STATE OF CONNECTICUT
CONNECTICUT SITING COUNCIL

APPLICATION OF NEW CINGULAR WIRELESS PCS,
LLC (AT&T) FOR A CERTIFICATE OF
ENVIRONMENTAL COMPATIBILITY AND PUBLIC
NEED FOR THE CONSTRUCTION, MAINTENANCE
AND OPERATION OF A TELECOMMUNICATIONS
TOWER FACILITY LOCATED AT THE FIRSTLIGHT
HYDRO GENERATING COMPANY PROPERTY AT
KENT ROAD IN THE TOWN OF NEW MILFORD,
CONNECTICUT

DOCKET NO. 444

NEW CINGULAR WIRELESS, PCS LLC (AT&T) RESPONSES TO CONNECTICUT
SITING COUNCIL PRE-HEARING QUESTIONS SET I

Flood Zone Map

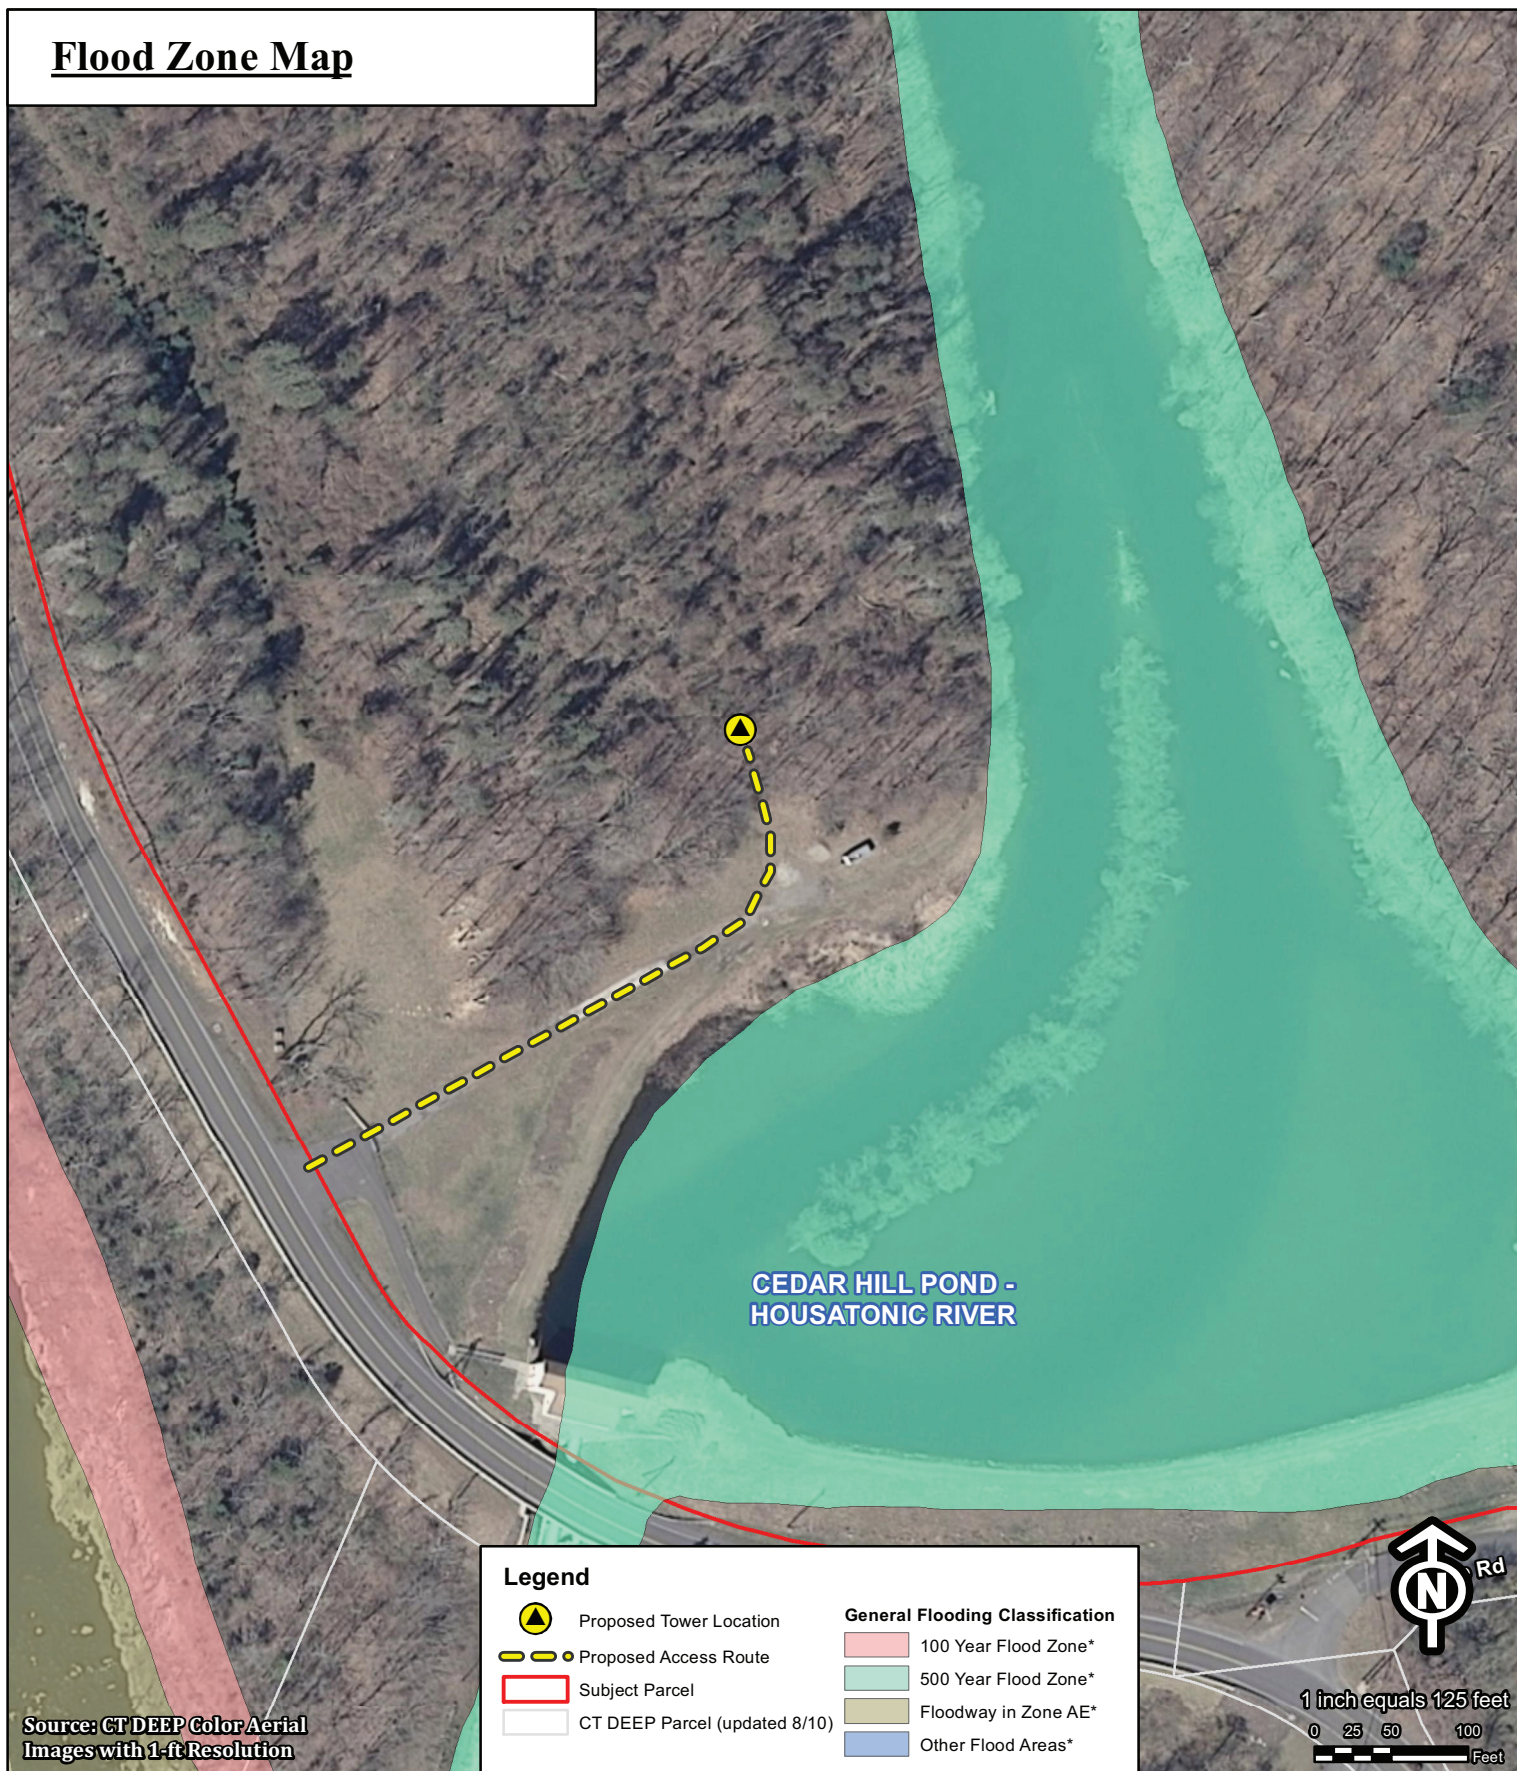
- Q6. Is the proposed site located within a 500-year flood zone?
- A6. *No. The site is located outside of the 500-year flood zone boundary associated with Cedar Hill Pond as shown in the Flood Zone Map included in Attachment 1.*

AT&T Proposed Coverage (850 MHz) with S4067 at New Milford, CT @ 136' AGL

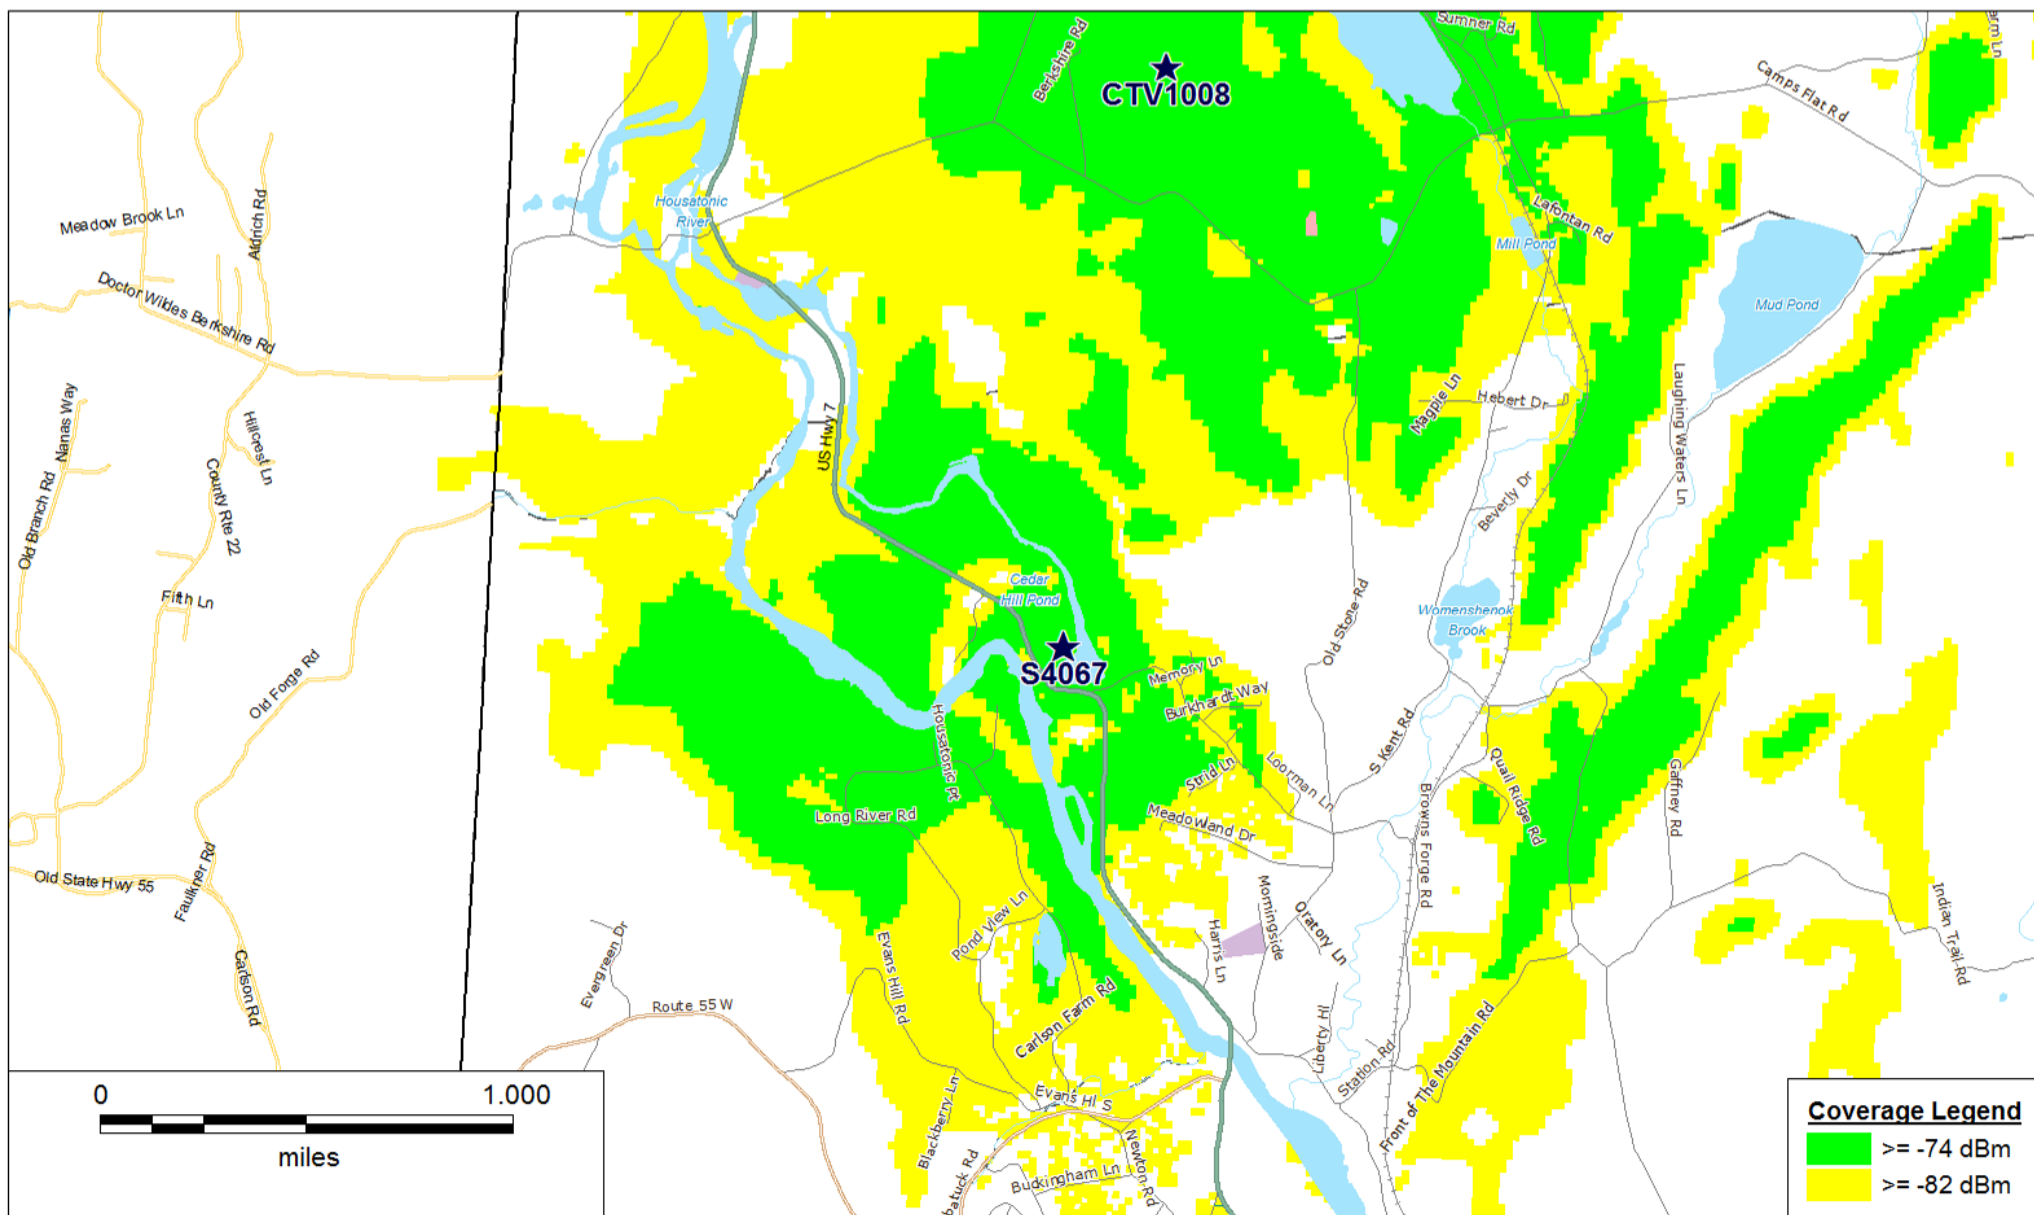
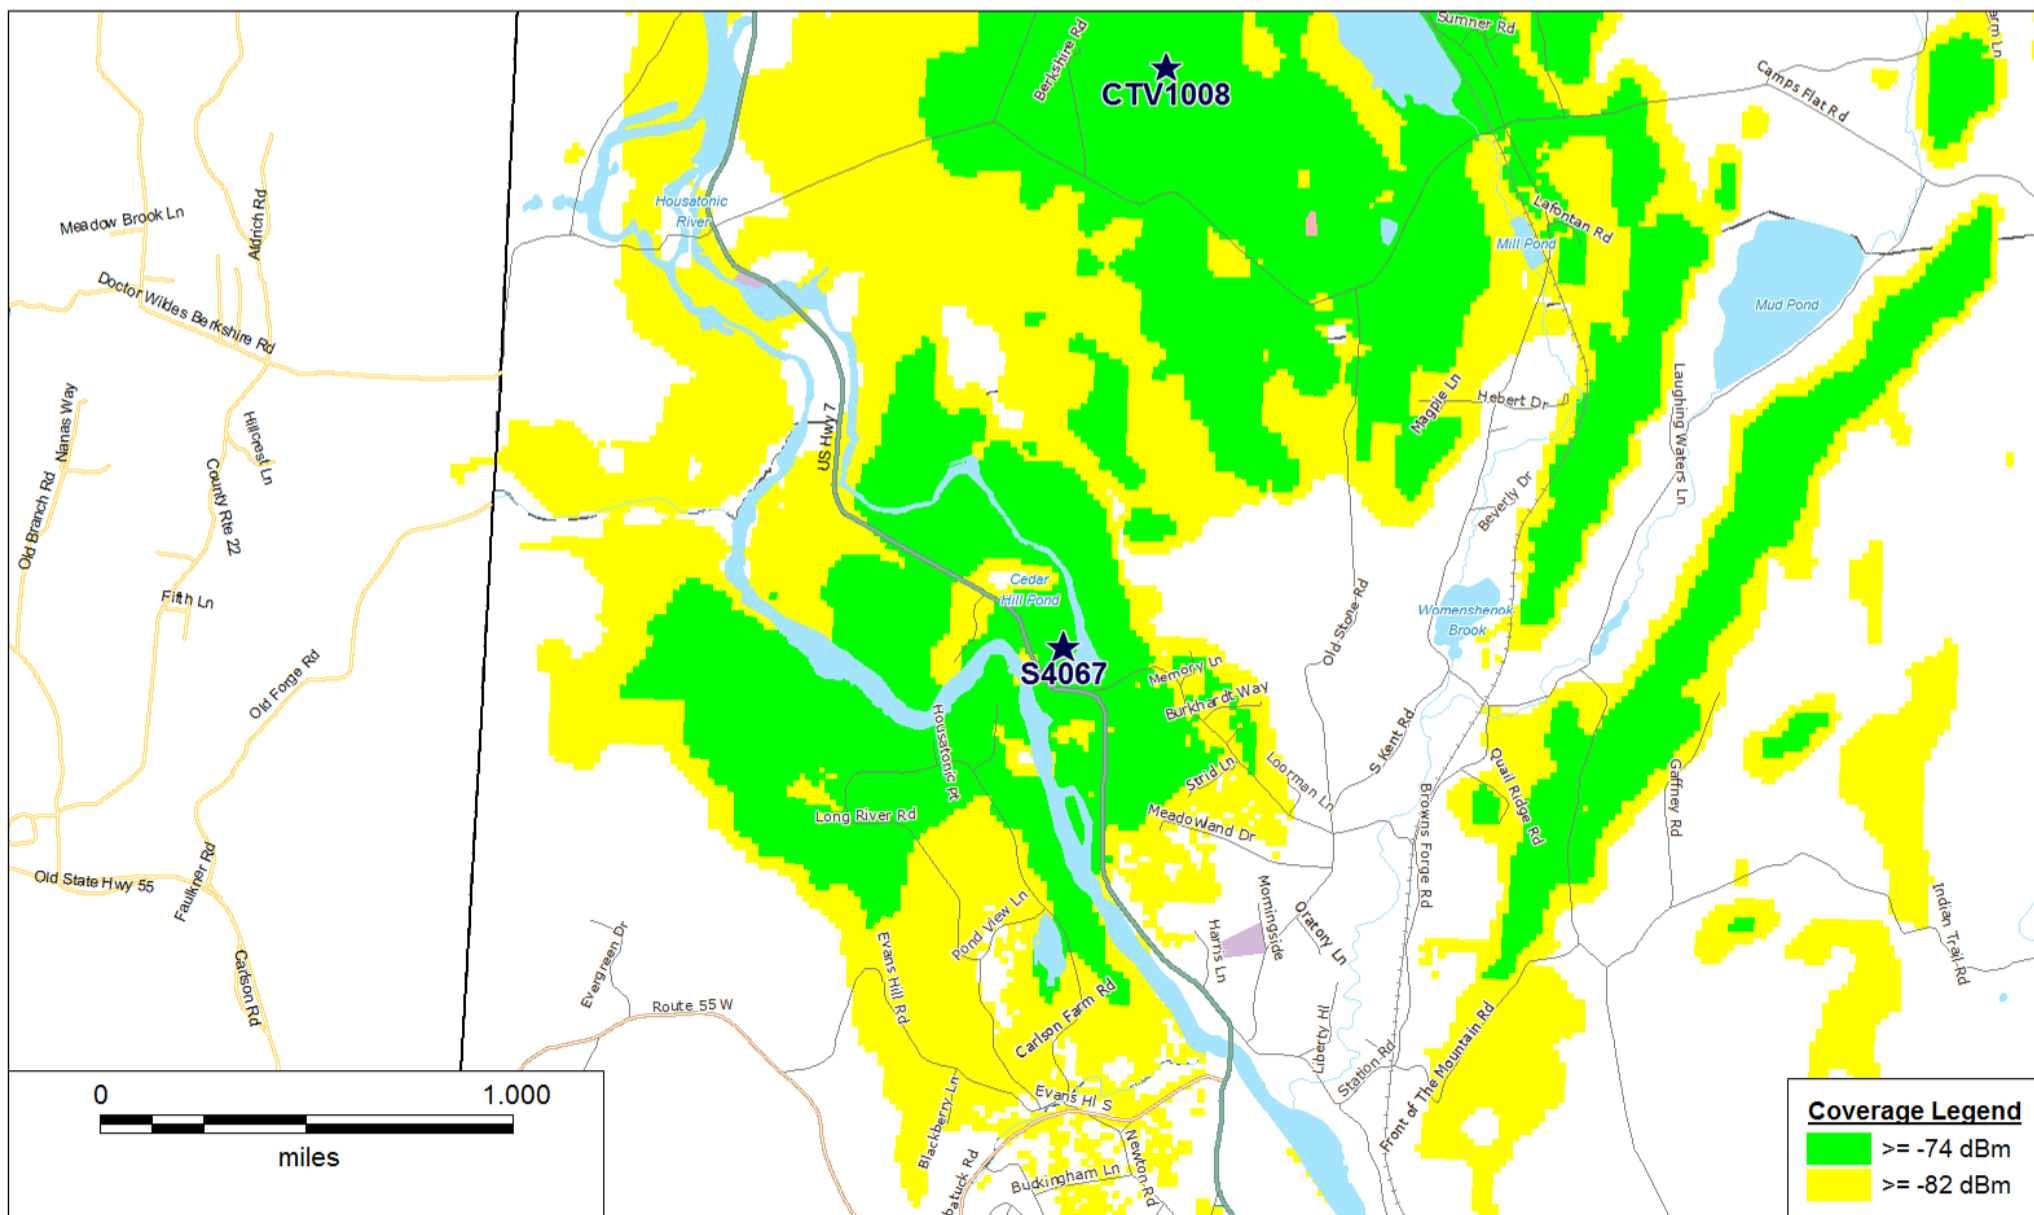
Q14. What is the lowest height at which AT&T's antennas could achieve its coverage objectives at the proposed site? Submit propagation maps showing the coverage at ten and twenty feet below these heights.

A14. *AT&T's coverage objectives are met at an antenna centerline mounting height of 146' AGL. The requested plots are included in Attachment 2.*

**ELEVATION,
PLAN AND
ANTENNA
CONFIG.**

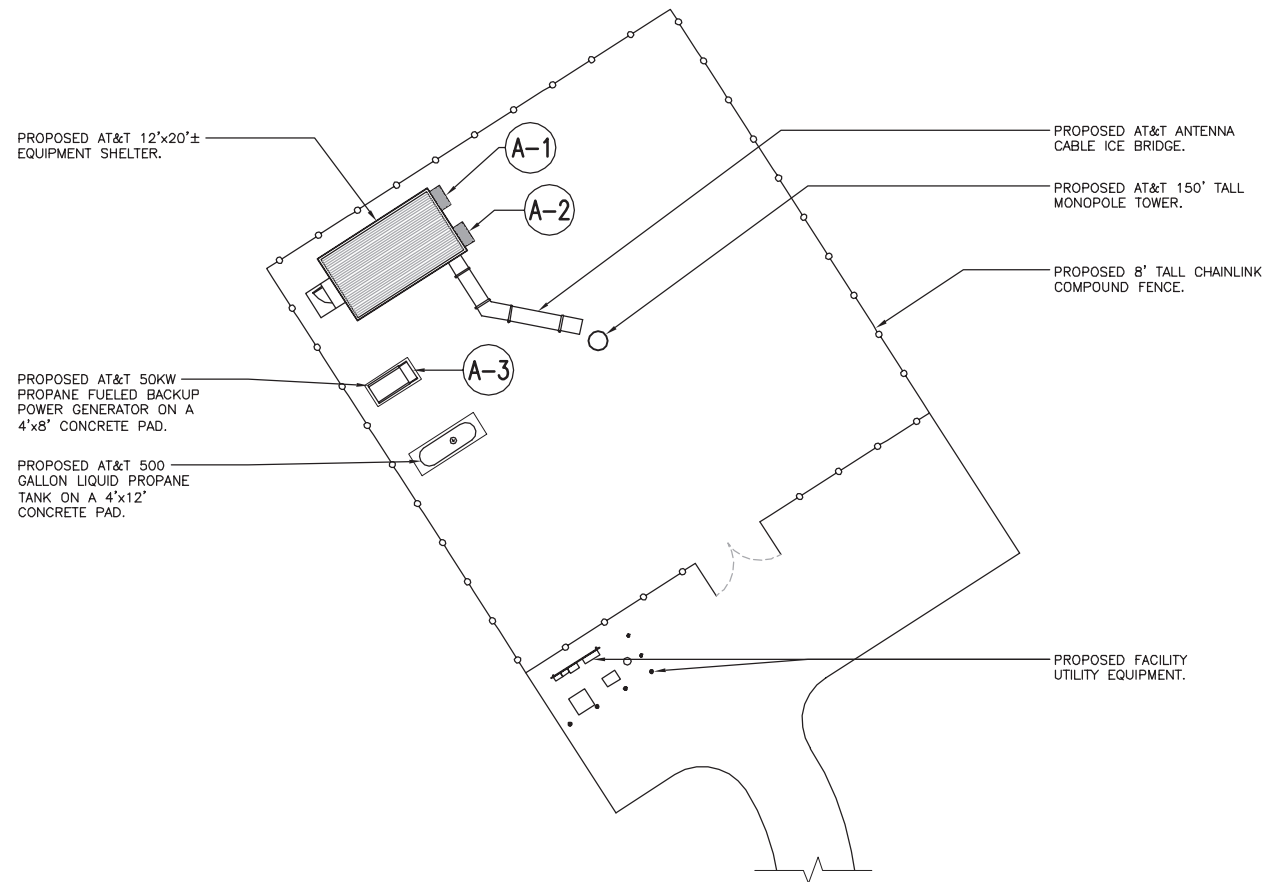
Q39. What is the expected cumulative noise level at the nearest property line from the proposed facility assuming the generator and air conditioning units are running at the same time? Provide a similar analysis only taking into account the air conditioning units.

A39. *The expected noise level at the nearest property line (west) with the generator and air conditioners operating simultaneously is 44 dBA. The expected noise level at the nearest property line of the air conditioners operating without the emergency generator is 32 dBA. Please see the noise study included in Attachment 3. As noted therein, the anticipated noise level of the air conditioners at the nearest property line complies with C.G.S. Sections 22a-69-1 through 22a-69-7 governing noise levels. It should also be noted that while the emergency back-up generator is exempt from compliance with the levels included in C.G.S. Sections 22a-69-1 through 22a-69-7, the attached noise study shows that operation of the emergency generator simultaneously with the air conditioning units also complies with the standards.*

The Regulation allows a noise level of 55 dBA (daytime) and 45 dBA (nighttime), when measured at a Residential Receptor's property line. I found that the two HVAC units running together without the generator; as well as the generator and two HVAC units running together; meet the conditions for compliance as set forth in the Regulation at all property lines.
